Docket Number:	97-AFC-01C
Project Title:	High Desert Power Plant
TN #:	216956
Document Title:	Energy Commission Staff Review of the Department of Fish and Wildlife Alto Transition Zone Water Balance Study
Description:	N/A
Filer:	AbdelKarim Abulaban
Organization:	California Energy Commission
Submitter Role:	Commission Staff
Submission Date:	4/11/2017 12:20:10 PM
Docketed Date:	4/11/2017

CALIFORNIA ENERGY COMMISSION STAFF REVIEW OF CALIFORNIA DEPARTMENT OF FISH AND WILDLIFE'S MOJAVE RIVER ALTO TRANSITION-ZONE WATER BALANCE ANALYSIS

Abdel-Karim Abulaban, Ph.D., PE, and Paul Marshall, PG, CHG, CEG

Figure 1 - Comparison between DMC plots when 10,000 AF or 20,000 AF is added to the net water balance

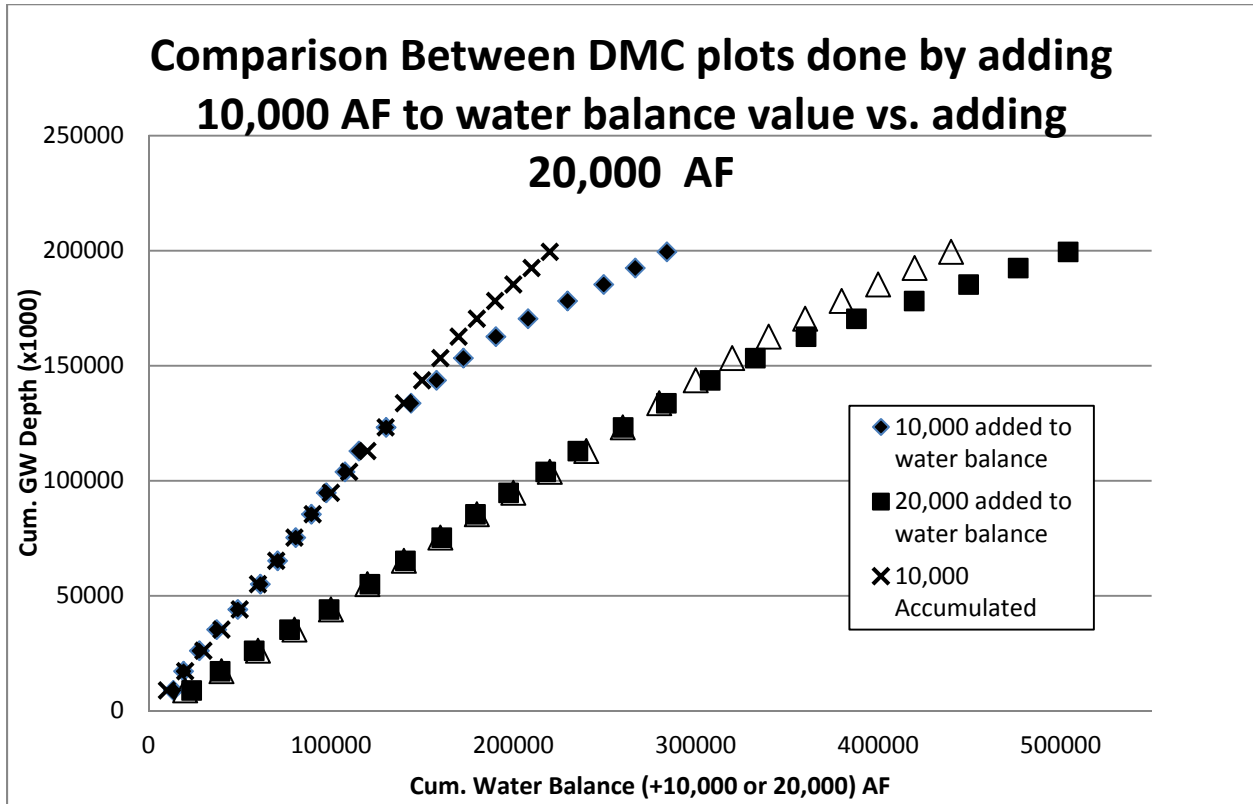
Contrary to what was stated in the water balance study, adding a constant value to either of the variables in a DMC analysis does change the slope of the relationship because the constant added to each value keeps growing as those values are consecutively accumulated. For example, the 10,000 AF added to each water balance value becomes 20,000 AF in the second cumulative sum, 30,000 AF in the third, and so on, up to 220,000 AF in the last sum since there are 22 data points in the record analyzed. To illustrate that adding a constant value to the variables used does affect the slope of the relationship, Staff performed the same analysis done in the water balance study, but added 20,000 AF to each water balance point instead of 10,000 AF, as was done in the CDFW study. A comparison between the plot obtained by Staff and the plot shown in Figure 13A of the water balance study is shown in **Figure 1** below to illustrate Staff's concerns with CDFW's statistical methodology. The relationship between the cumulative values is significantly changed when 20,000 AF was added compared to the case where 10,000 AF was added. By adding the larger value it had the effect of making the relationship more linear and the slope much flatter (almost half the slope of the plot for the DMC analysis in CDFW's water balance study).

Figure 1 also shows a plot of the added 10,000 AF and 20,000 AF constants accumulated on their own without the accumulated water balance values. As stated above, and as illustrated in **Figure 1**, the reason a more linear plot was obtained when a constant value was added to the water balance data is that the cumulative sums of the actual data are much smaller compared to the cumulative sum of the artificially added constant, such that variations in the actual cumulative sums of the data became too small to be detected by the naked eye. It is clear in the figure that for the most part, the plots of just the sums of the added constants cannot be distinguished from the plots of the cumulative sums of the water balance data with the constants added.

In light of the foregoing, Staff concludes that the results of the DMC analysis presented in the CDFW water balance study are erroneous and cannot be relied upon.

Even without the errors in the DMC analysis discussed above, the quantity used for the analysis is not appropriate. The appropriate variable to use in the DMC analysis is the change in water table elevation, because this is the variable affected by the net water balance of the groundwater basin. Thus, the DMC analysis should be performed using those two quantities.

Figure 2 - DMC plot using winter groundwater elevations and net water balance

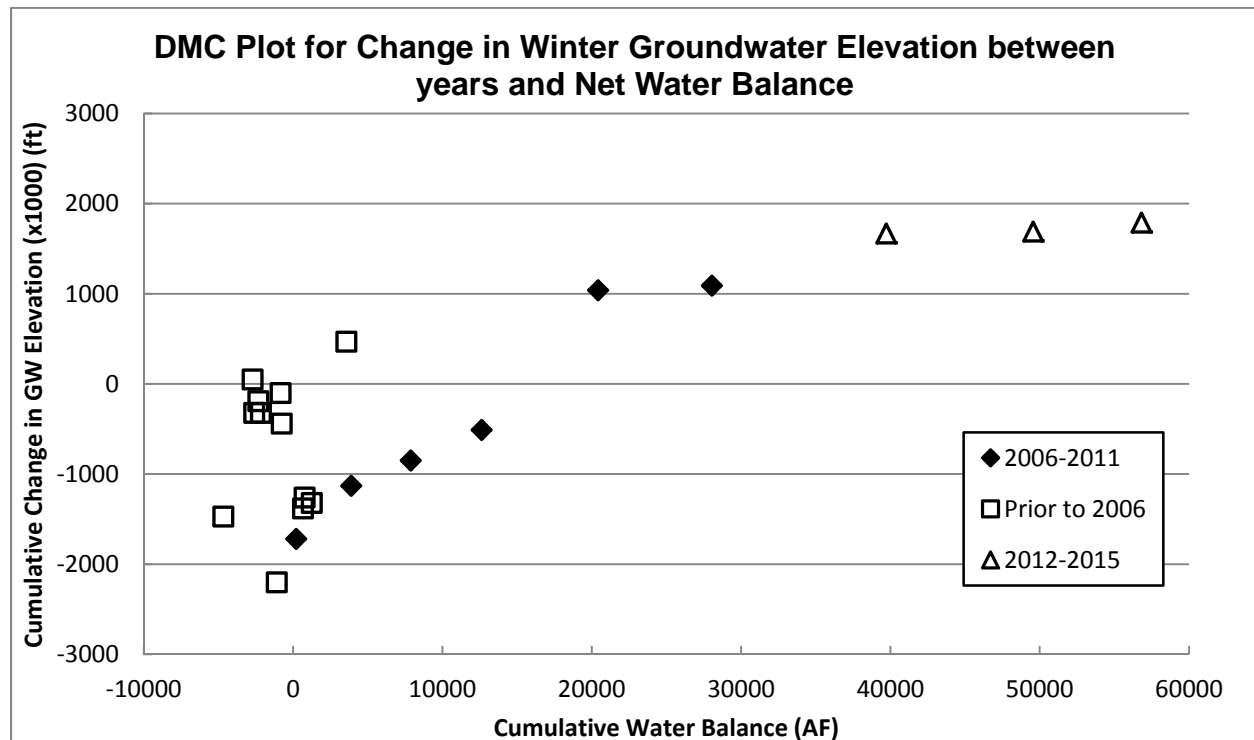
Staff performed an independent analysis using the data given in Table 1A of the CDFW water balance study to determine whether using the appropriate application of the same methods used in the CDFW analysis would show some correlation in the data. In the analysis, Staff used the same data and assumptions as CDFW regarding the major inflow and outflow components for the basin balance described above. Staff performed the DMC analysis on the net water balance against the change in groundwater table elevation. **Figure 2** below shows the DMC plot for the water balance and the change in groundwater table elevation using the winter groundwater elevation data assumed to be caused by the previous year’s flows.

Both **Figures 2** and **3** show a pronounced correlation for the data starting in 2006 through 2011. Also, both figures show that the correlation for the data beyond 2011 is not as strong, but still much better than the pre-2006 portion of the plots. The behavior beyond 2011 might have been due to the severe drought period that the state of California experienced. Because of the drought, reliance on groundwater was heavier and resulted in faster declines in water table levels (MWA 2017). Therefore, if the first half of the data are excluded because there is no correlation between the data sets, and if the last part of the graph corresponding to the drought years is ignored because it deviates from the trend exhibited by the middle portion, one is left with the linear portion from 2006 through 2011.

Figure 3 - DMC plot using summer groundwater elevations and net water balance

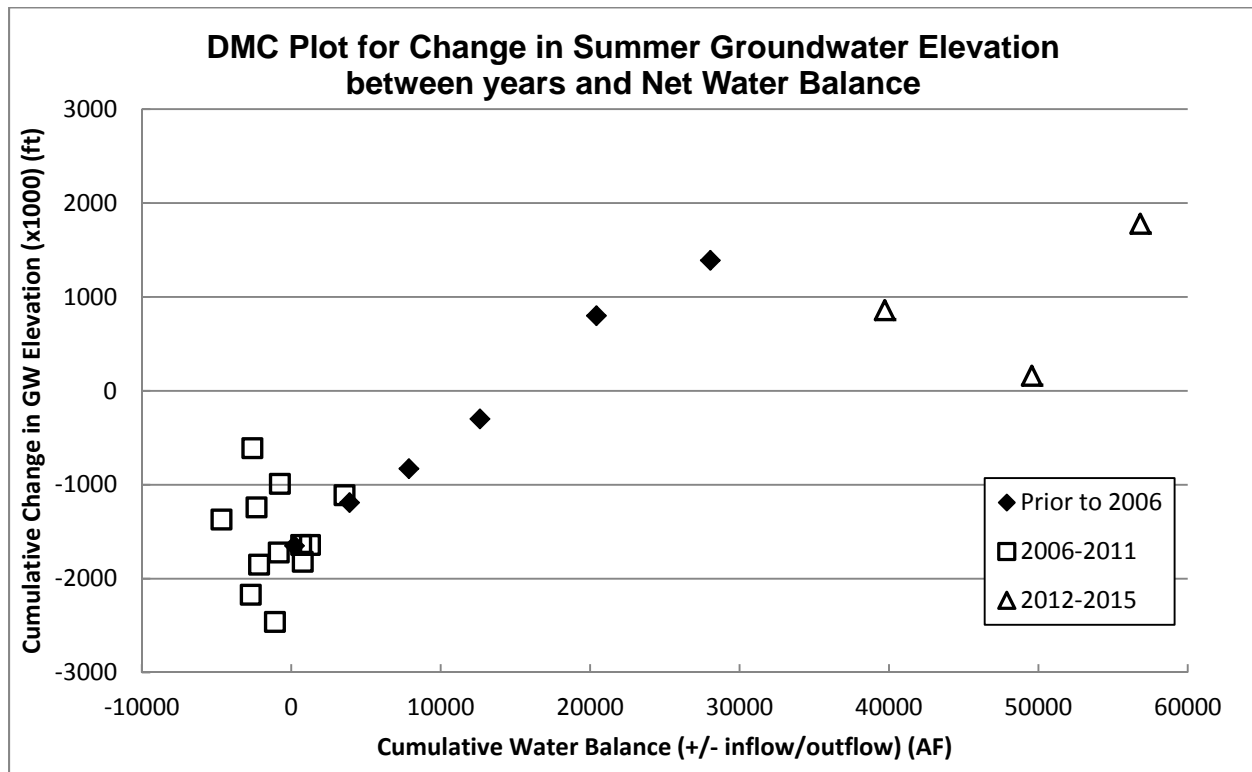
Staff also performed the DMC analysis for the net basin balance and the change in groundwater table elevation using the summer groundwater elevation data listed in Table 1B of the CDFW study. The DMC plot for this case is shown in **Figure 3** below. As can be seen from both **Figure 2** and **Figure 3**, the data prior to 2006 do not exhibit any discernible relationship. This is likely due to the assumption that many of the values for the basin balance variables are constant. This also could have been caused by the presence of some inflow or outflow components that have not been accounted for in the CDFW analysis. As discussed above, USGS water resource studies show the gradients between upper and lower aquifers in the TZ change during seasons and at different

However, this is not supported by the information presented in the CDFW water balance study. For example, **Figure 3**, as well as Figure 8A, shows that the water table has remained below the 7-ft trigger throughout the whole record analyzed. Yet, in a previous submittal by CDFW, it was stated that the TZ vegetation has been improving and the density of the vegetation has been increasing for the most part of the record (CDFW 2016). Additionally, requiring that the groundwater table elevation be maintained above the 5-8 ft. depth below ground surface is in conflict with the adjudication judgment that required the water table in the key well to be no more than 10 ft. below ground surface.

Figure 4 - DMC plot for winter groundwater elevation changes beyond 2006, with a linear regression fit for data points between 2006 and 2011

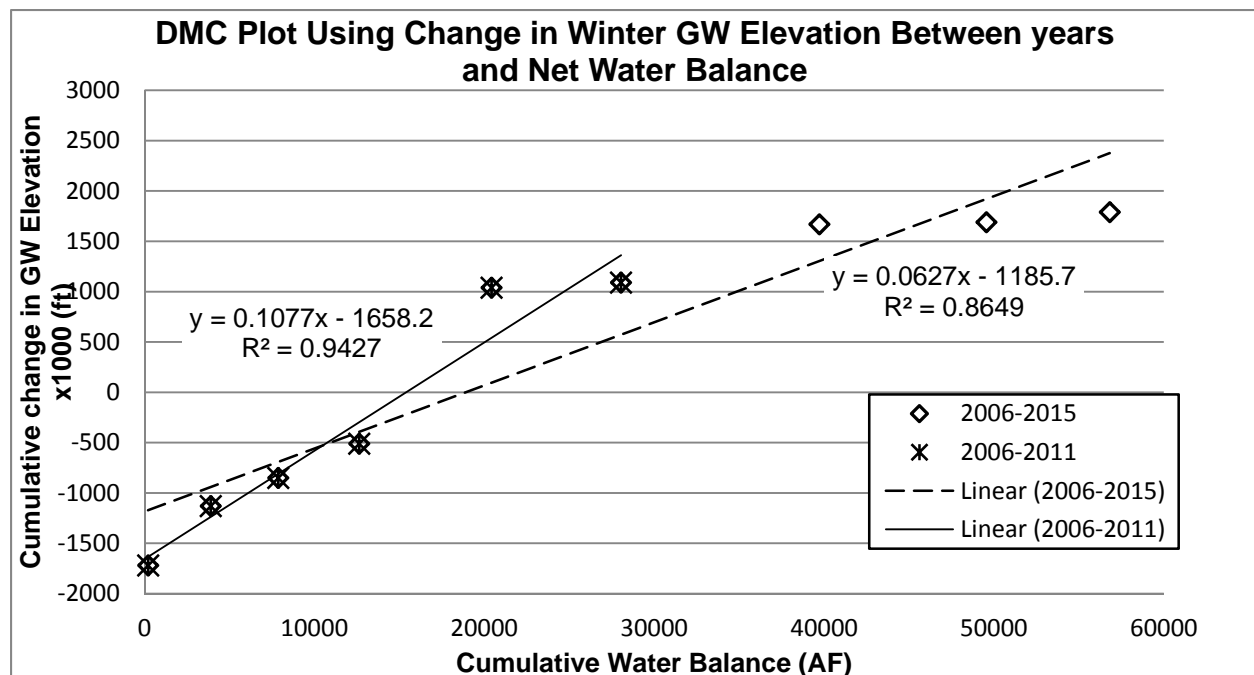
The linear portion of both graphs has been fitted with a linear regression line as shown in **Figures 4** and **5**. The coefficient of determination was 0.94 for the plot using winter groundwater elevation changes, and 0.99 for the one using the summer water elevations. Both coefficients of determination indicate a very good fit between the data and the fitted linear relationship.

Both of the fitted regression lines have very close slopes of about 0.11. The slope indicates that withdrawal of 1,000 acre-feet from the TZ results in 0.11 ft. of groundwater table drawdown, or 9,000 acre-feet for a 1-ft drop in the water table elevation. The fact that the linear portions of both graphs were fitted with two lines having very similar slopes gives confidence that this may be closer to the true relationship for the data analyzed, given all the questionable assumptions about the components of the water balance equation.

Using the slope of the fitted linear regression lines, Staff concludes that diversion of 3,000 AFY or so of recycled water for HDPP might cause a fraction of a foot (0.33 ft) of a drop in the water table. It can be said with confidence that this is within the margin of error of the input data, whether they were individually measured or due to the assumptions that several of the major water balance components were assumed constant throughout the 22 years used in the analysis. Staff also understands that use of such a small data set may not demonstrate significant statistical significance. Overall the data set suggest there is no significant linear relationship between changes in groundwater elevation and the net basin balance. Using a simple linear regression is not appropriate for this data. The groundwater system in the TZ appears to be complex and changes in groundwater elevation are likely governed by non-linear relationships. Also, use of fixed value assumptions for many important variables in the basin balance is likely not appropriate for anything other than the simple basin accounting system used for the groundwater basin adjudication for which it was designed.
